March 10, 2025

Mr. David Randall  
Senior Planner  
DRandall@FresnoCountyCA.gov  
Fresno County Public Works and Planning Department  
Development Services and Capitol Project Division  
2220 Tulare St., 6th Floor  
Fresno, California 93721

Re: Draft Environmental Impact Report SCH #2020060123, EIR No. 7763 (Draft EIR) For the Proposed Unclassified Conditional Use Permit Application Nos. 3666 and 3667, CEMEX Rockfield Quarry Project

TYPICAL E-W CROSS SECTION  
SCALE 1" = 100'

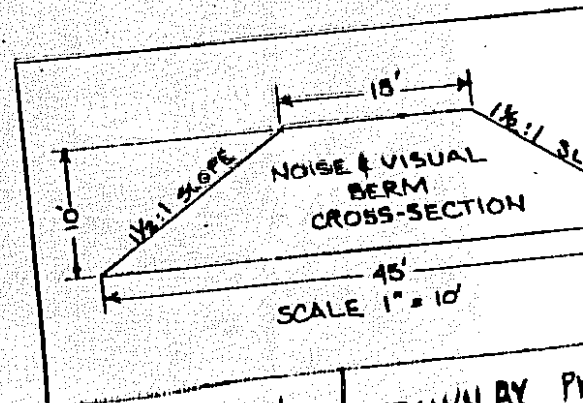
The setback from San Joaquin River is a project feature of CUP 2032 and is more precisely identified in the Mining Plan cross section attached to the CUP (a copy of which is attached hereto as Exhibit 3), which identifies the approved plan’s setback from the San Joaquin River as:
